**FAXED ADDENDUM to the REQUEST FOR BID
Bartlett Regional Hospital (BRH) Radio Communications System
Design and Installation
RFB No. E11-063**

ADDENDUM NO.: TWO

DATE ADDENDUM ISSUED: November 1, 2010

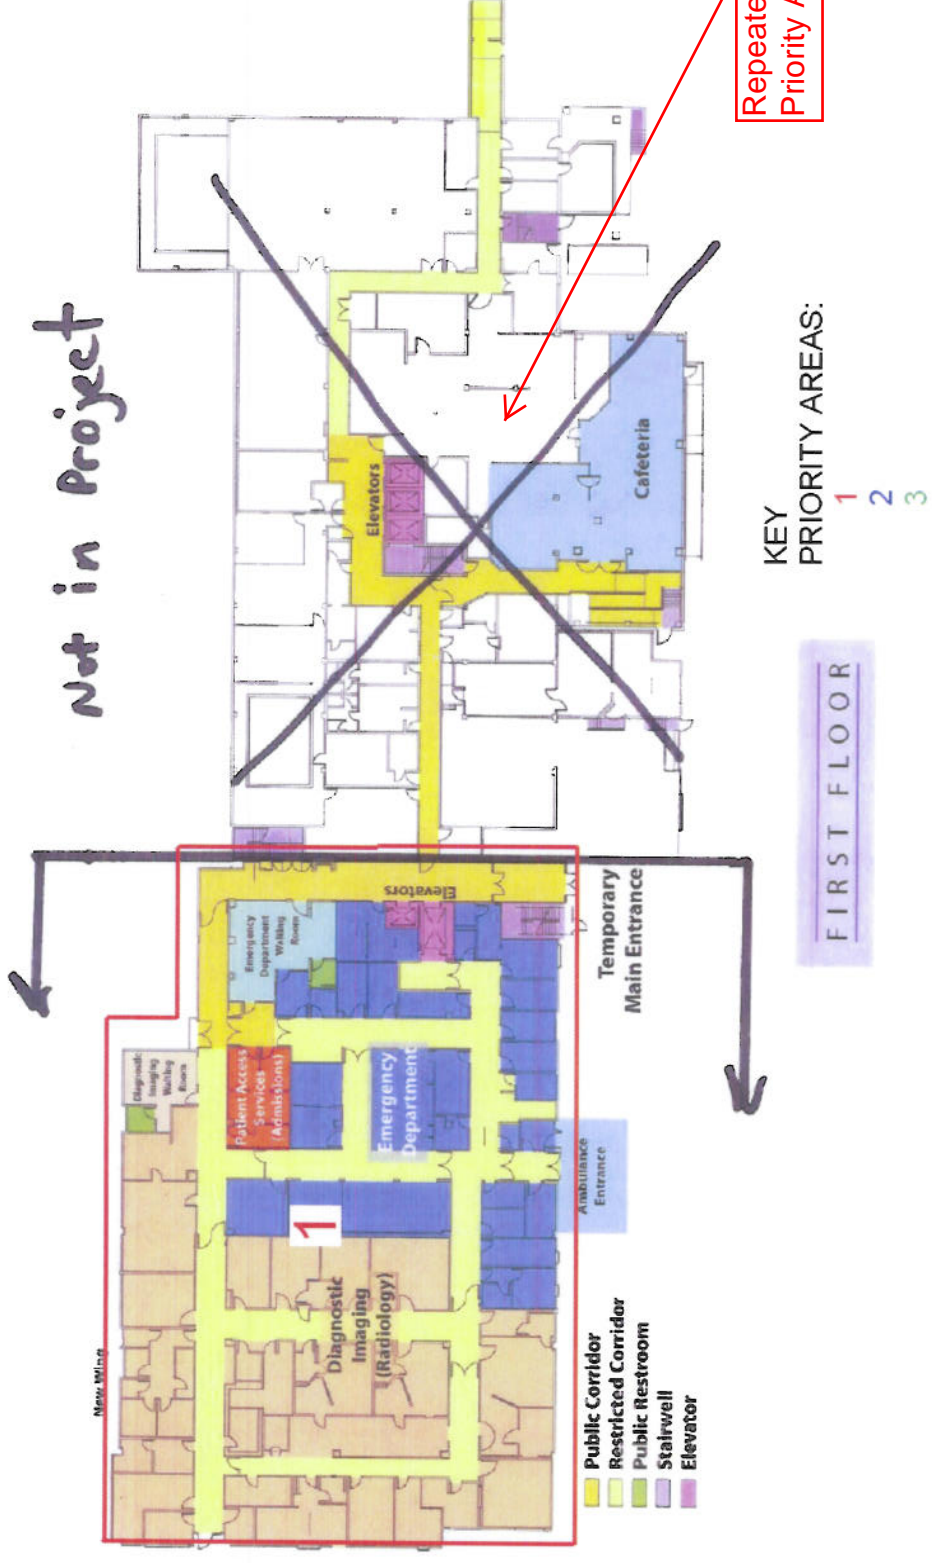
Base Bid: Perform all work described in this bid document for design and installation of an in-building Radio Communication System within the Level 1 Priority Areas designated on the attached floor plans, including the Emergency Department and Diagnostic Imaging (Radiology) on the First Floor and the Mental Health Unit on the Third Floor. Base Bid work requires BDA and Repeater coverage for these areas.

BDA Coverage: Critical Care Unit, Bartlett Beginnings, Former Admissions Lobby, Physical Occupational Therapy, all on the Second Floor.

Repeater Coverage: Former Admission Lobby and Physical/Occupational Therapy on the Second Floor, and the First Floor area listed as “Not in Project”.

Note: It is understood that Repeater Coverage for areas designated on the drawings as “Not in Project” will not involve any physical installation work in those areas, but rather coverage from a distance. The minimum coverage level required by the Repeater shall meet the same requirements as the BDA in specified areas.

THIRD FLOOR

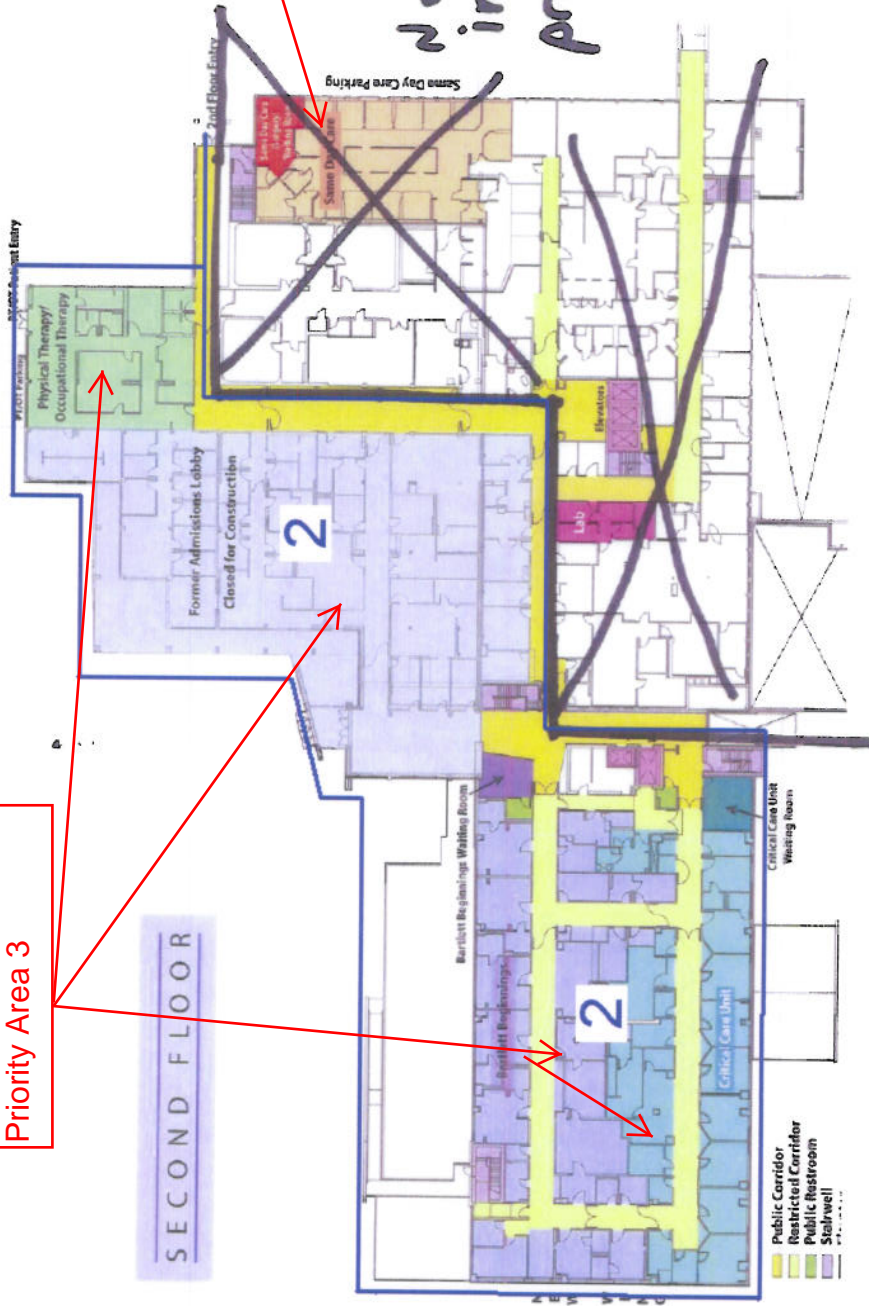
Repeater Coverage: Critical Care Unit, Bartlett Beginnings, Same Day Care on the Second Floor, and Medical/Surgical Patient Rooms on the Third Floor.

BDA Coverage: Medical Surgical Patient Rooms on the Third Floor.

Repeater Coverage:
Priority Area 3

Repeater
Coverage:
Priority Area 2
